**Cobra 139XLR Technical Bulletin 1218**

## COBRA FIELD BULLETIN BULLETIN 1218

SUBJECT: COBRA 139XLR MODIFICATIONS

**FIGURE 1**

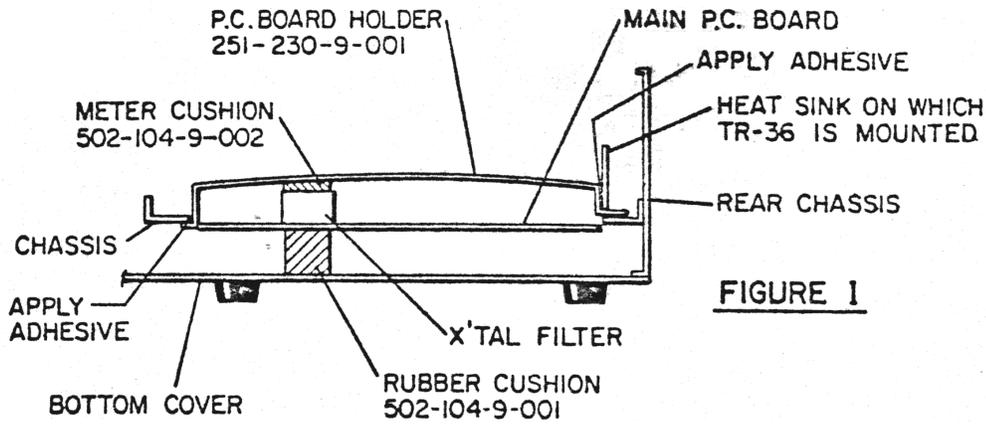
16. Paste two meter cushions (520-104-9-001) on top of Xtal filter (Fig. 1)

18. Install PC board holder (Longer flange under auxiliary heat sink, shorter flange under chassis)  
Fig 1.

**FIGURE 2**

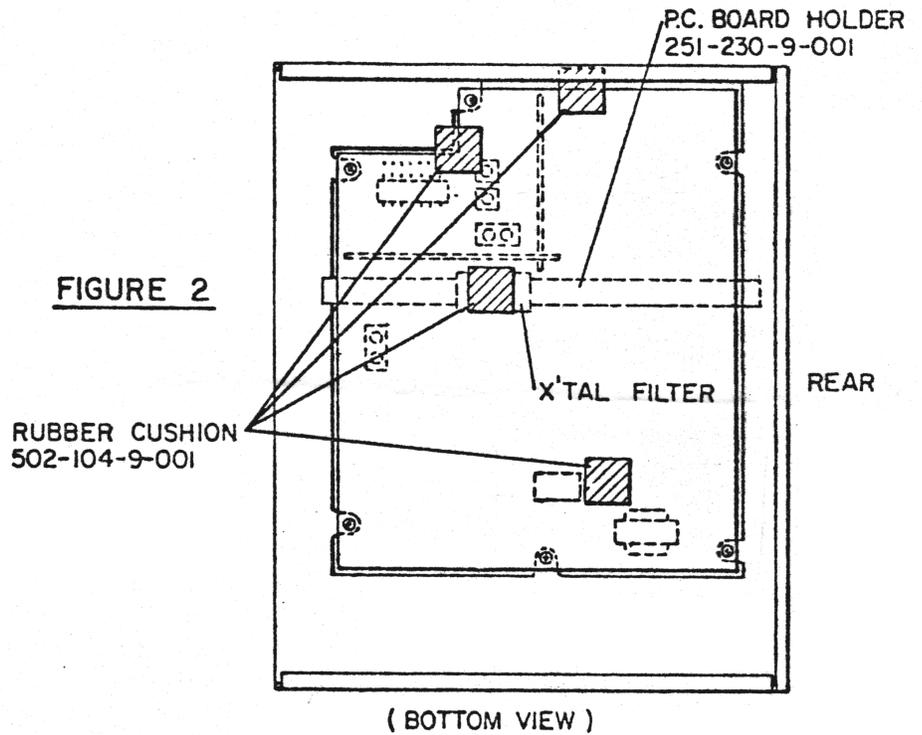
14. Remove backing paper from four rubber cushions (502-104-9-001) and paste cushions on solder side of PC board (Fig 2).

To avoid damaging lead wires or components, locate rubber cushions in areas of board that are clear of lead wires and components.

**FIGURE 3**

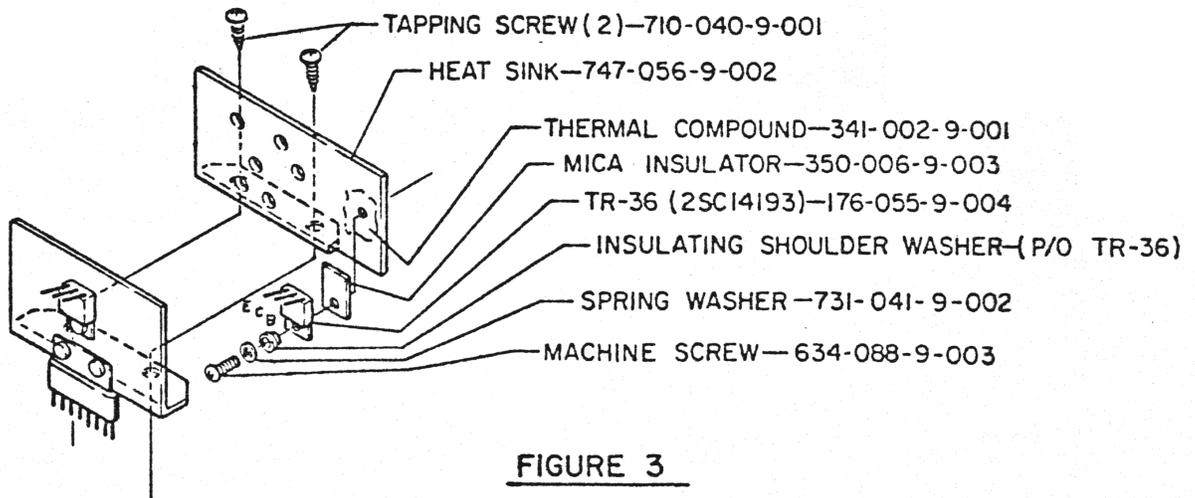
7. Unsolder and remove TR-36 from present location.
8. Mount TR-36 on auxiliary heat sink (747-056-9-002 supplied with this mod. kit) using the existing hardware and insulators (Fit. 3). Apply thermal compound (341-002-9-001) on both sides of mica insulator before installation. When installing insulated shoulder washer, make sure that the smaller end seats in transistor hole. When tightening transistor mounting screw be careful not to damage insulated shoulder washer.
